Product Change Notification (PCN)

PCN Number	509679	Date Issued	February 17, 2021
Reason for Change	Packaging Method/Quantity Changing		
Change Type Description	This letter is to inform you that the part(s) referenced in this notice will undergo packaging specification changes that may include a new Delivery unit, packaging size, changes to the label or packaging material. No changes will be made to the product as a result of this change.		
Assessment of Change	Drop test approved		
Internal Molex Qualification Date	November 30, 2020		
Sample Availability Date (Changed Part)	November 30, 2020		
Planned Implementation Date	August 17, 2021

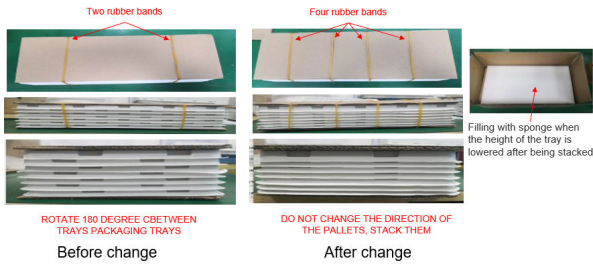
In order to reinforce packaging, reduce the impact of transportation on product quality, we plan to modify the packaging method. Detail as following:

- 1. In order to reinforce packaging, reduce the impact of transportation on product quality, we plan to modify the packaging method.
- 2. Product Impact
 - No impact to fit, form or function
 - No change to DU
- 3. Part Number Impact
